# E-3 AWACS CORROSION PREVENTION ADVISORY BOARD (CPAB)

12 JULY 1990  
TINKER AFB, OK

**E-3 CORROSION PREVENTION ADVISORY BOARD MINUTES  
12 JULY 1990**

Figure 13-13A. Antenna Pedestal Center Section EMP Structural Finishes **HCI** (Sheet 1 of 10)

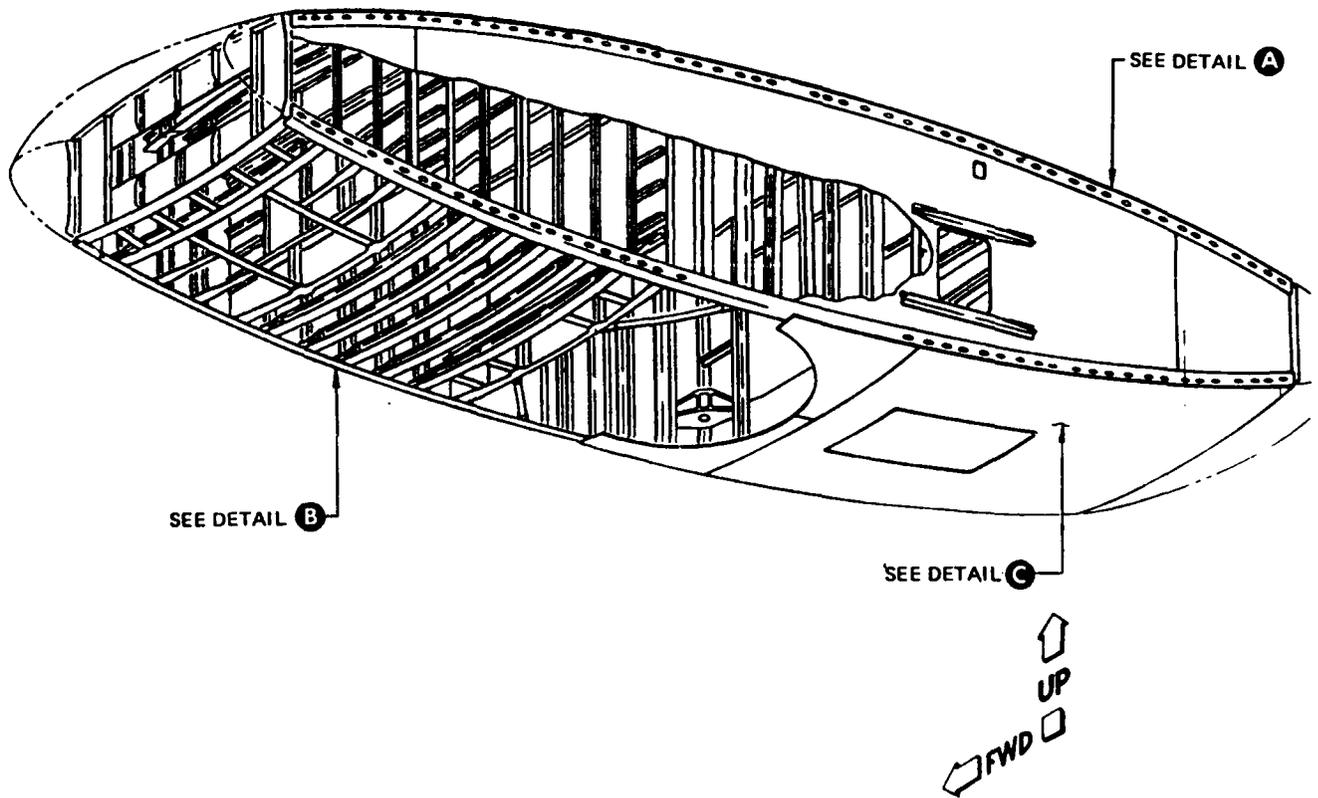
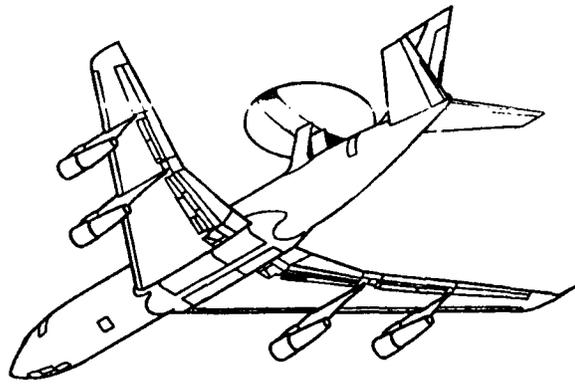
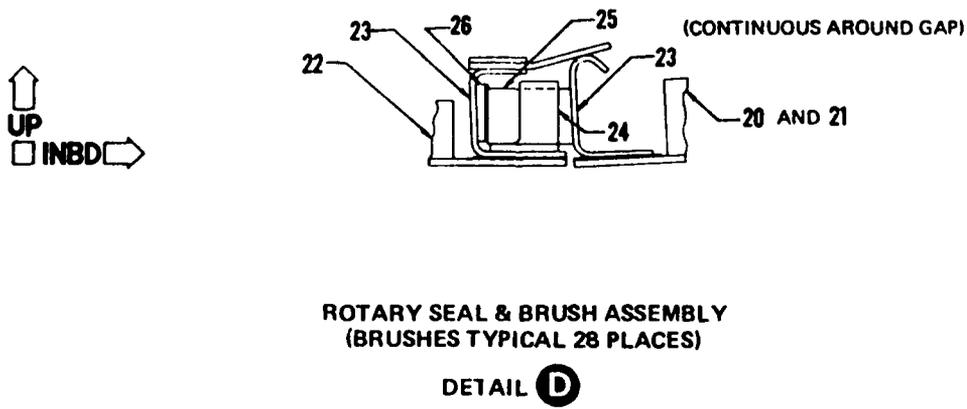
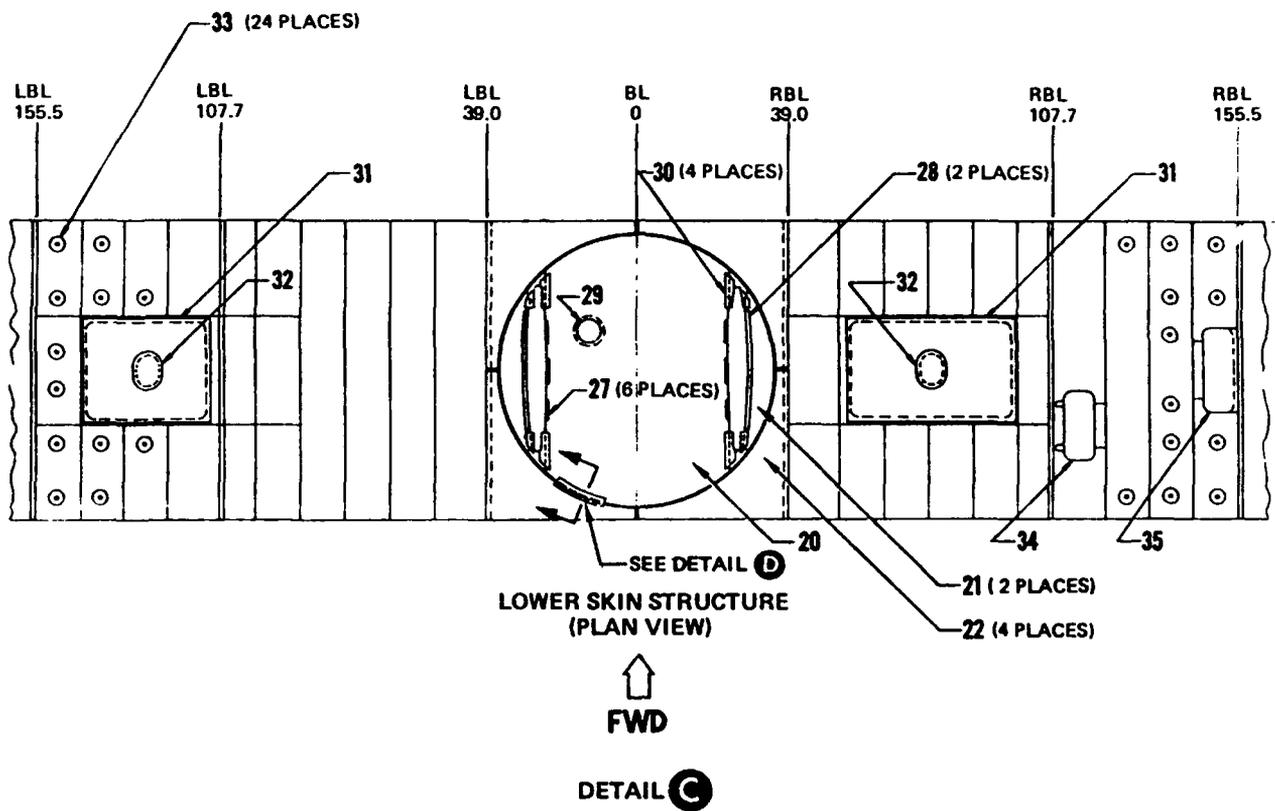
E-3	CORROSION PREVENTION ADVISORY BOARD	ACTION ITEM #: 88-29
O R I G I N A T O R	<b>SUBJECT:</b> Corrosion on Access Doors in Rotodome Hardback	<b>BACKGROUND DATA:</b> <b>PART NUMBER:</b> 204-20111; 204-20121; 204-20107 <b>NSN:</b> <b>DRAWING(S):</b>
	<b>NAME:</b> Sgt. Luhm <b>ORGANIZATION:</b> 552d AWACW/MAEB <b>TELEPHONE:</b> (405)733-3826 <b>DATE SUBMITTED:</b>	<b>TO(S):</b> 1E-3A-23 <b>FIGURE:</b> 13-13A <b>INDEX:</b> 31,32 <b>WORK UNIT CODE:</b>
	<b>PROBLEM:</b> Rotodome hardback access doors have tin plated filler strips mounted to the access doors and the periphery of the structure. Excessive corrosion is reworked and tin strips replaced during phase inspections. These are HCI and are time consuming and costly to repair.	
	<b>RECOMMENDED ACTION:</b> Investigate design configuration and other related corrosion problems in this area. Recommend alternative materials to replace the tin plating.  <p style="text-align: center;">(USE CONTINUATION SHEET IF NECESSARY)</p>

3. Repair: The -31 and -32 installations may be repaired per T.O.1E-3A-3-1 Section VII Paragraph 7-12 and Figure 7-9. This procedure may also be used to convert the -1 and -2 installations to the -31 and -32 installations. This will provide better corrosion protection.

552 AWACW has not completed inspections of access doors. MMKRA will coordinate a TCTO with MMKRTA to change tin plated filler strips on USAF and NATO aircraft.

552 AWACW has not inspected cad plated filler strips for corrosion on aircraft noted in May 1989 status.

**FIGURE 5: JOINT LOCATIONS**

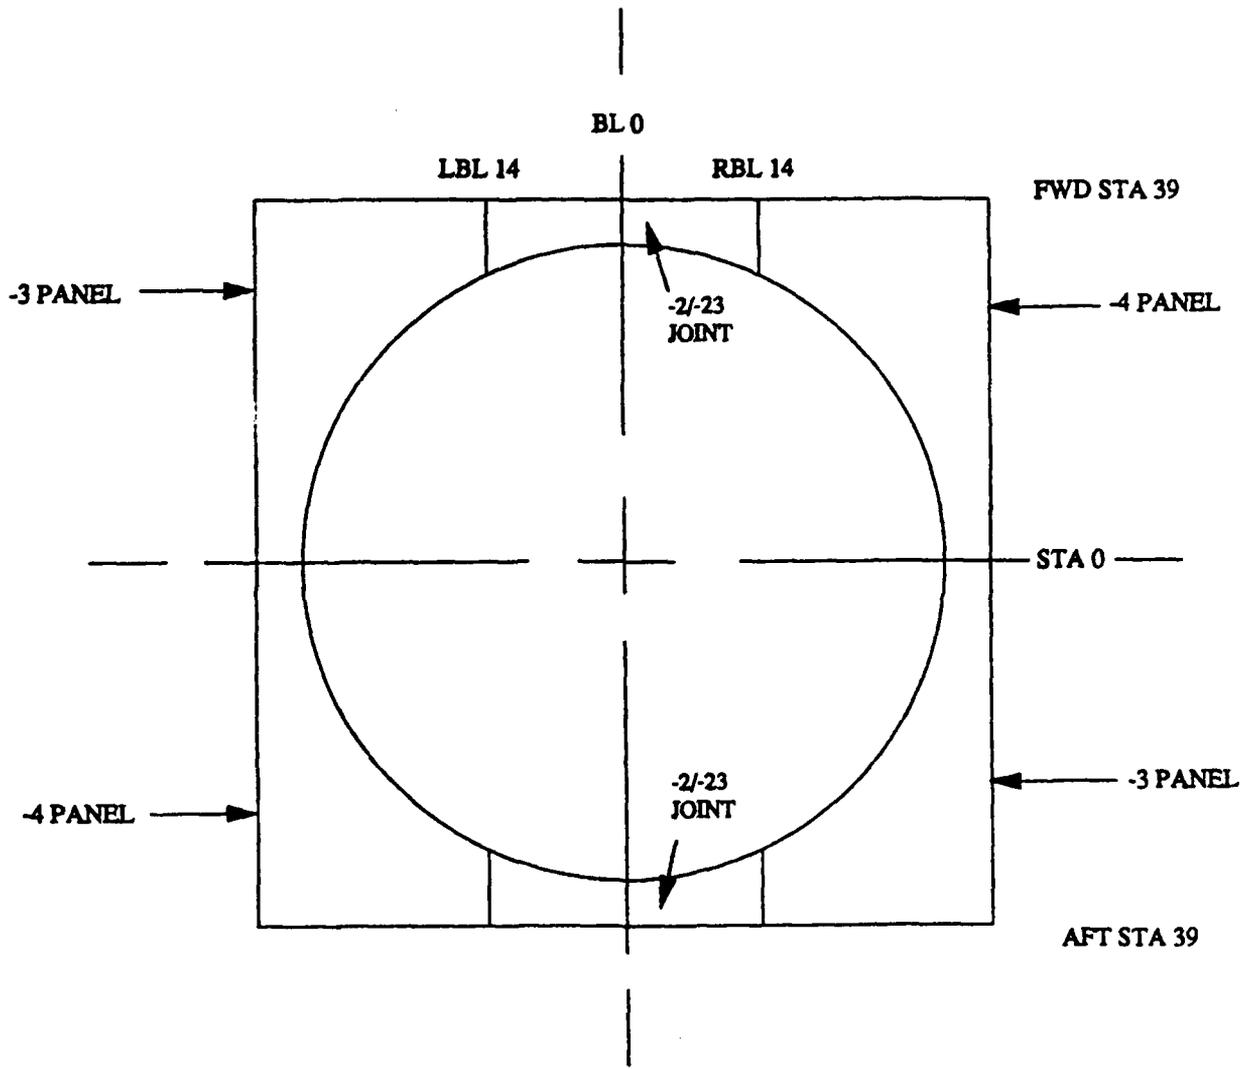
E-3	CORROSION PREVENTION ADVISORY BOARD		ACTION ITEM #: 88-30
O R I G I N A L T O R	<b>SUBJECT:</b> Antenna Pedestal Closure Panels/Splice Plates	<b>BACKGROUND DATA:</b>  <b>PART NUMBER:</b> 204-20133  <b>NSN:</b> <b>DRAWING(S):</b>	
	<b>NAME:</b> Josef Deckers <b>ORGANIZATION:</b> NAEWF/Comp/LWMQ <b>TELEPHONE:</b> 49 2451-63-363 <b>DATE SUBMITTED:</b> 15 NOV 1988	<b>TO(S):</b> 1E-3A-18; 1E-3A-4-93-3 <b>FIGURE:</b> 4-9 ; 7D <b>INDEX:</b> ; 12 - 17 <b>WORK UNIT CODE:</b>	
	<b>PROBLEM:</b> Extensive corrosion is found on the tin plated closure panels and splice plates. Moisture migrates into the area and the tin plated parts corrode.		
	<b>RECOMMENDED ACTION:</b> Evaluate the original design and recommend alternative materials. Determine if problem exists in USAF fleet. Recommend solutions.  <p style="text-align: center;">(USE CONTINUATION SHEET IF NECESSARY)</p>		
C P A B A C T I O N	<b>STATUS:</b> May 1989: Boeing evaluated the problem and found the following: 1. Review of Design: a. Corners: The four corners consist of bonded aluminum honeycomb panels (204-20133-3, and -4, two each) which are tin plated on the upper surface of the outboard flange (7075 aluminum). These tin plated surfaces are attached to chemically treated 7075 clad aluminum plates. These plates are attached to primed 7075 aluminum fittings (204-20136). See Figures 5 and 6. b. Sides: The sides are tin plated 7075 bare aluminum panels (204-20133-2) which are wash primed, primed, and enamelled. These panels are attached to tin plated clad 7075 aluminum fillers (204-20133-23). These fillers are also attached to the primed strongback extrusions at STA 39. See Figures 5 and 6. 2. Repair: See T.O. 1E-3A-3-1, Section VII, Figure 7-3, Detail V for damage allowances after corrosion removal and refinishing. 3. Recommended Solutions: a. Corners: Fillers (204-20133-19, -22, -25 and -26)  <p style="text-align: right;">(continued)</p>

A/C 79-0459 No corrosion between splice plates and closure panels, but tin plated surface of the closure panels on several places corroded. Filler panels show discoloration.

All actions not yet completed by MMKRA. No ECO will be issued to change part numbers. Part number changes done by Boeing only. Tech Orders will be changed to require local fabrication of new parts during rework using chemically treated Clad 7075 aluminum.

Figure 2-5. Fillet Flap Flaperette Corrosion Inspection Guide (Sheet 1 of 2)

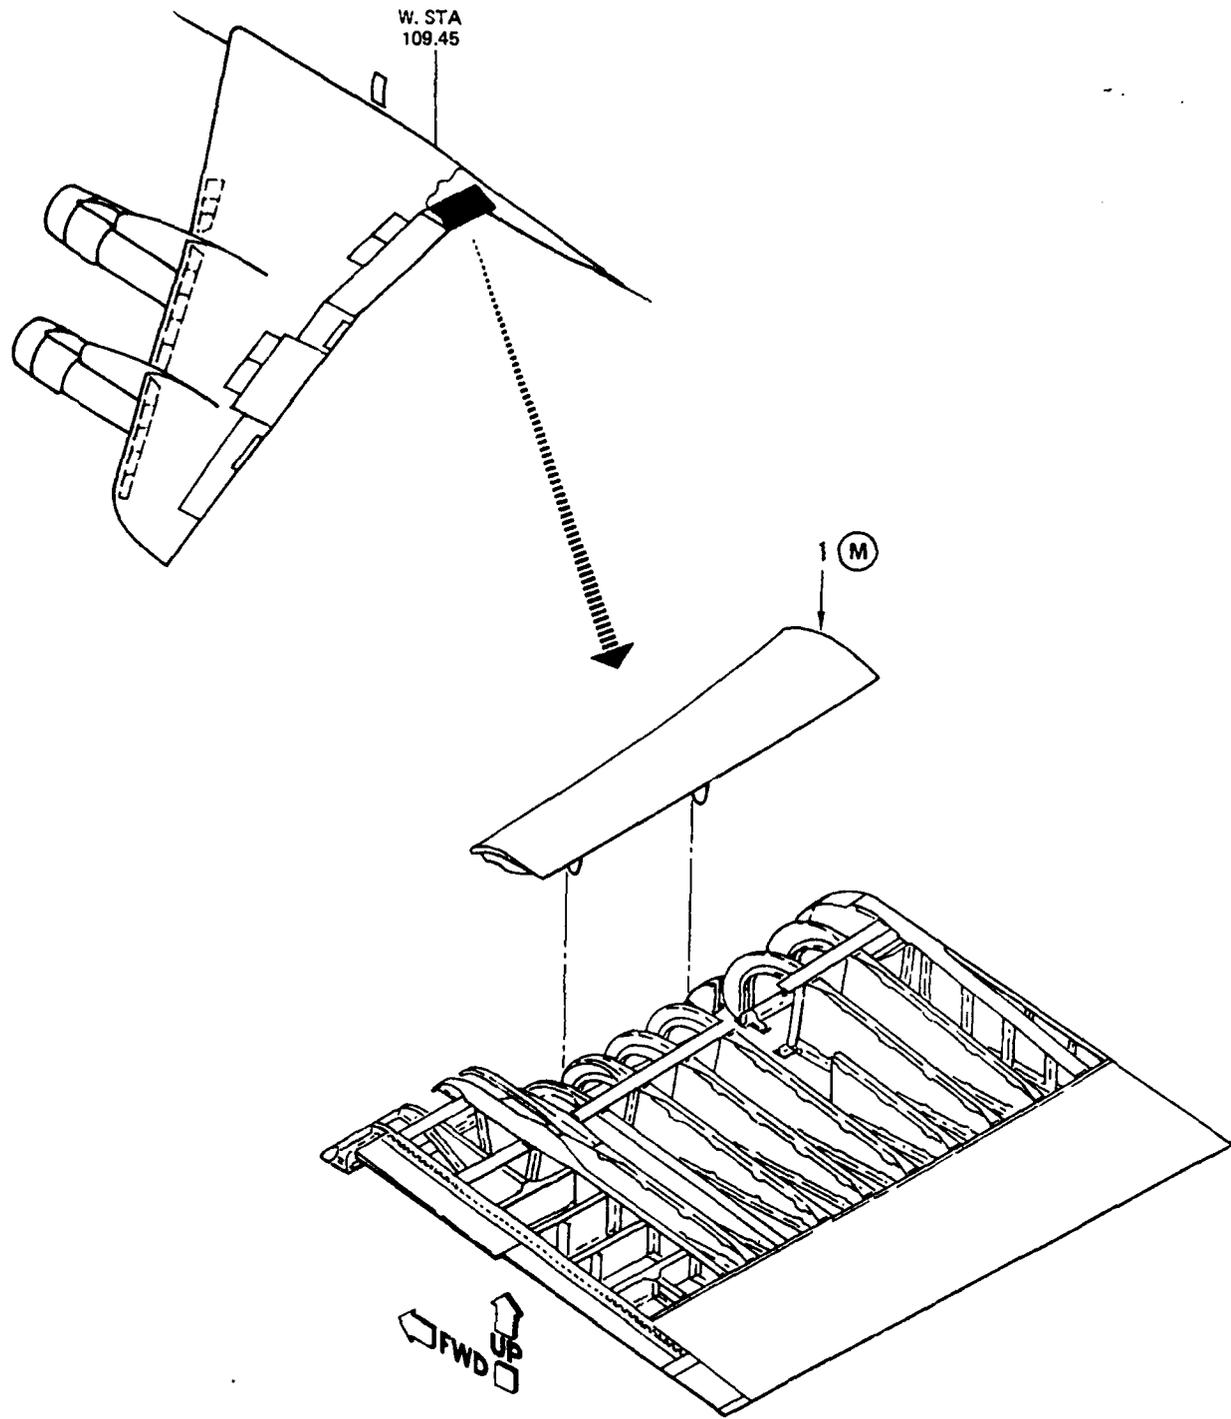
E-3	CORROSION PREVENTION ADVISORY BOARD		ACTION ITEM #: 88-31
O R I G I N A L O R	<b>SUBJECT:</b> Fillet Flap Flaperette Corrosion		<b>BACKGROUND DATA:</b>  <b>PART NUMBER:</b> 65-19178  <b>NSN:</b> <b>DRAWING(S):</b>
	<b>NAME:</b> Josef Deckers <b>ORGANIZATION:</b> NAEWF/Comp/LWMQ <b>TELEPHONE:</b> 49 2451-63-363 <b>DATE SUBMITTED:</b> 15 NOV 1988		<b>TO(S):</b> 1E-3A-23; <b>FIGURE:</b> 2-5 <b>INDEX:</b> 1 <b>WORK UNIT CODE:</b>
	<b>PROBLEM:</b> The brush seal that contacts the upper surface of the flaperette seems to be holding moisture and contaminants and causing corrosion on the upper forward surface of the flaperette.		
<b>RECOMMENDED ACTION:</b> Determine purpose and material of the seal, suggest alternatives to the seal and/or determine if better finish requirements are needed to protect the flaperette underneath the seal.  (USE CONTINUATION SHEET IF NECESSARY)			
C P A B A C T I O N	<b>STATUS:</b>  Jan 1989: Abrasion resistant teflon coating could be applied to the flaperette to add an additional layer of corrosion protection and chafing protection.  May 1989: MMKRA will change T.O. 1E-3A-23 to require finishing the flaperette with teflon coating.  BOEING will provide procedures for applying the abrasion resistant teflon coating to the flaperette.  Nov 1989: Brush seal is made of mohair and is an aerodynamic seal. EST 89-E3B2-13 is a task to Plastic Media Blast (PMB) various magnesium parts. This part is one which will be PMB'd. After blasting, it will be repainted with teflon coating added. At this time procedures for applying the coating will be developed. (continued)

NAEWF E-3A Component will perform a normal prepaint surface treatment and add teflon coating to test the adhesion and wear characteristics, and will report results at next CPAB.

NAEWF E-3A Comp. reported that A/C -0456, treated with Lixton compound with teflon coating on 30 Nov., is in good condition when inspect on 30 June. Another aircraft treated the same way on 30 Dec. is also currently in good condition. So far, the coating is adhering to the surface with Lixton. A/C -0457 will be similarly treated soon.

Once field tests are completed by E-3A Component, OC-ALC/MMKRA will include instructions to apply teflon coating after corrosion rework in T.O. 1E-3A-23, Figure 2-5 Corrosion Inspection Guide.

Figure 13-16. Abrasion-Resistant Teflon Coating Locations (Sheet 5 of 6)

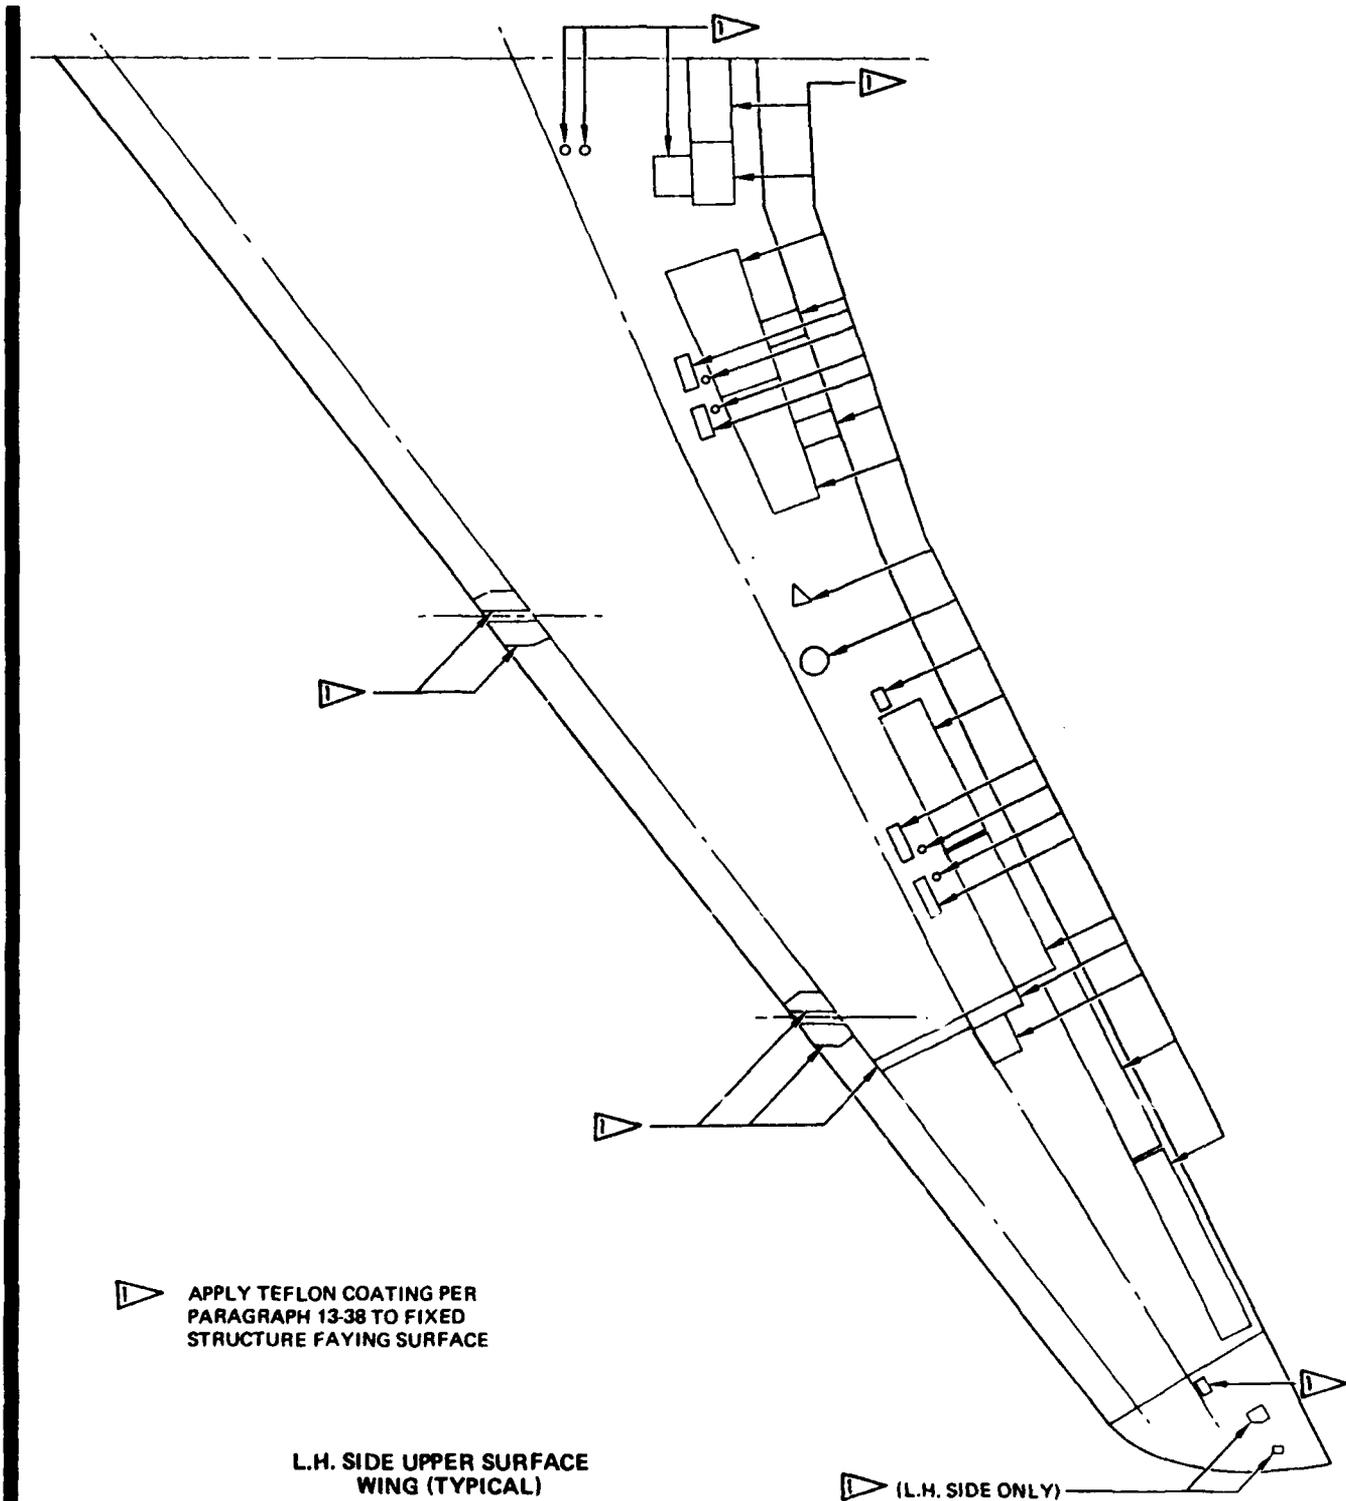
E-3	CORROSION PREVENTION ADVISORY BOARD	ACTION ITEM #: 88-32
O R I G I N A L T O R	<b>SUBJECT:</b> Abrasion Resistant Teflon Coating on Faying Surfaces	<b>BACKGROUND DATA:</b> <b>PART NUMBER:</b> 7-W-27 or 7-X-74 <b>NSN:</b> <b>DRAWING(S):</b>
	<b>NAME:</b> HFW Franz-Josef Deckers <b>ORGANIZATION:</b> NAEWF E-3 Comp. <b>TELEPHONE:</b> 01-49-2451-63-6215 <b>DATE SUBMITTED:</b> 15 NOV 1988	<b>TO(S):</b> 1E-3A-23 <b>FIGURE:</b> 13-16 ; para. 13-38 <b>INDEX:</b> entire figure <b>WORK UNIT CODE:</b>
	<b>PROBLEM:</b> Teflon coating is applied on faying surfaces during manufacture to prevent fretting. The areas of application listed in T.O. 1E-3A-23 fig. 13-16 are incomplete. Requirements for inspection and replacement of the teflon coating are non-existent.	
	<b>RECOMMENDED ACTION:</b> Ensure reapplication requirements are included in tech data, and ensure figure 13-16 is updated to include areas in engine cowlings, nacelles, and fuselage that require teflon coating reapplication.  (USE CONTINUATION SHEET IF NECESSARY)

Black color stocklisted and previously thought as being teflon coating is not. Material used by C/KC-135 is an erosion coating similar to what is used on E-3 radomes. OC-ALC/MMKRTA is preparing T.O. 1E-3A-23, par 13-38 changes in teflon coating application procedures to white on gray and gray on white application, instead of the previous white - white, gray - gray procedure. This change would prevent having to generate new stocklisting action and would provide the color differential as requested.

Statement of work for a Boeing EST has already been submitted by MMKRA. Procedures for application are available in T.O. -23.

SEE NOTE ON PARTS LIST PAGES  
FIGURE 17. DUCT INSTL, WING LEADING EDGE CABIN AIR (SHEET 1)

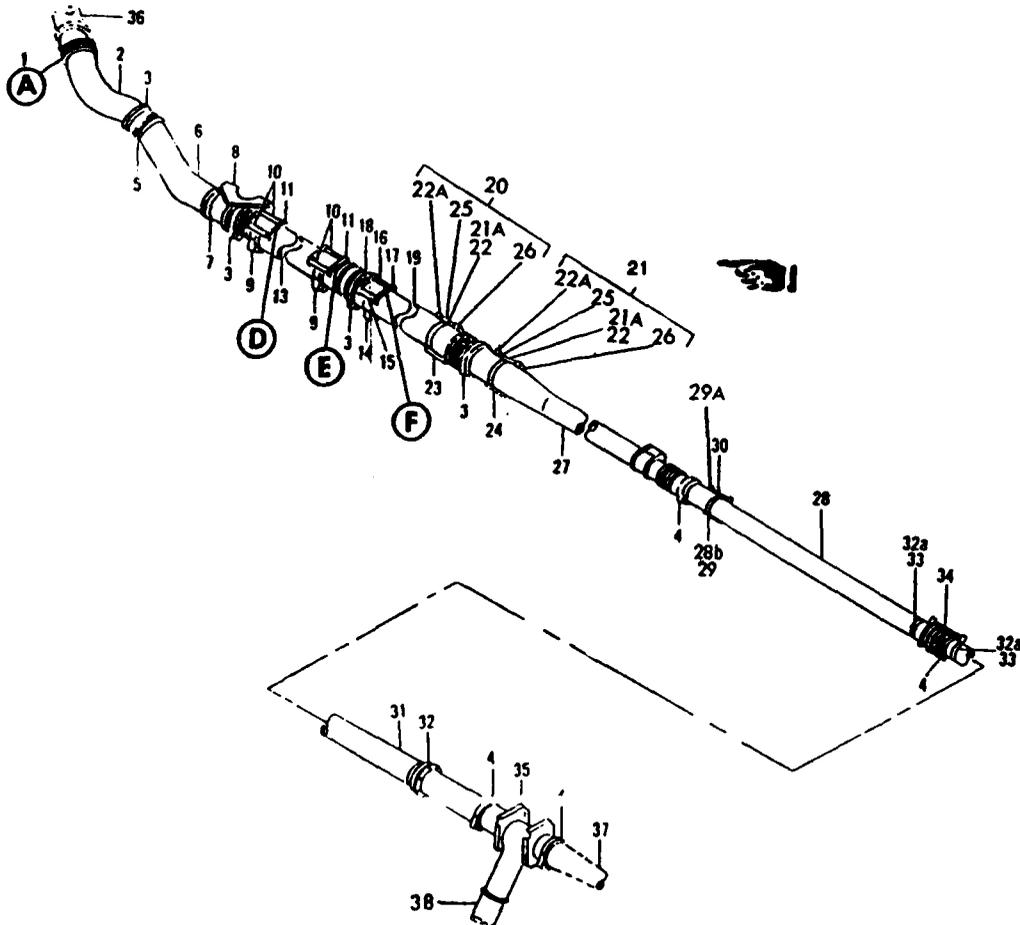
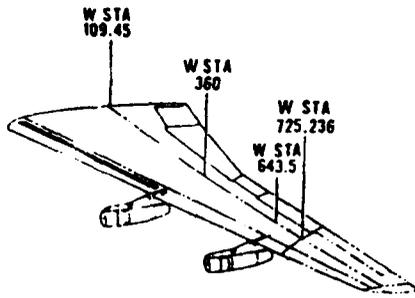
Statement of work for L.E. skin will require removal of bleed air ducts. MMKRA will look again at bleed air ducts and replace it as necessary. The diameter for the out-board ducts are .016" and for the in-board ducts are 050". Maximum allowable pitting for out-board and in-board are .002" and .003" respectively. If replacement ducts are not available, MMKRA will generate repair procedures.

NAEWF E-3 Component reported no corrosion found on ducts.
